**Space systems — Test procedure to
evaluate spacecraft material ejecta
upon hypervelocity impact**

**AMENDMENT 1: Oblique impacts and
Annex C update**

Reference number
ISO 11227:2012/Amd.1:2021(E)

Figure C.3 — Sketch of target and witness plate assembly for oblique impact

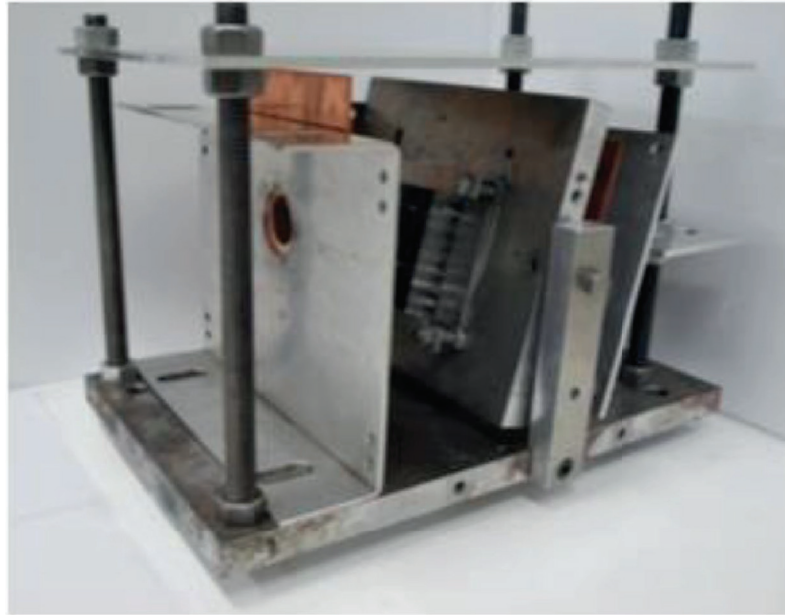
Add the following two figures after Figure C.2 and renumber the subsequent figures:

- 1 target
- 2 witness plate (top)
- 3 witness plate (front)
- 4 witness plate (back)

NOTE The front witness plate can be removed when the front ejecta is negligible.
